MIL-P-17639F (SH)
 AMENDMENT 4
 22 FEBRUARY 1996
 SUPERSEDING
 AMENDMENT 3
 25 May 1995

PUMPS, CENTRIFUGAL, MISCELLANEOUS SERVICE,
 NAVAL SHIPBOARD USE

This amendment forms a part of MIL-P-17639F(SH), dated 18 February 1986, and is approved for use within the Naval Sea Systems Command, Department of the Navy and is available for use by all Departments and Agencies of the Department of Defense.

FIGURE 1A - IMPELLER BETWEEN BEARINGS

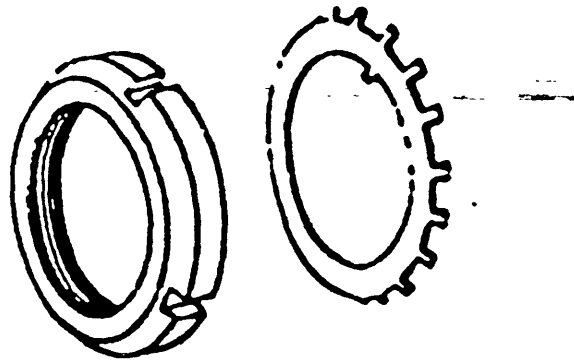
3.3.5.?: Delete and substitute:

"3.3.5.2 Impellers shall be keyed or, the shaft and securely held against movement by locked nuts or other means approved by the design review agency (see 6.2.1). Impellers between bearings shall be restrained in a manner similar to that shown in Figure 1A. Impellers not between bearings shall be restrained in a manner similar to that shown in Figure 1B."
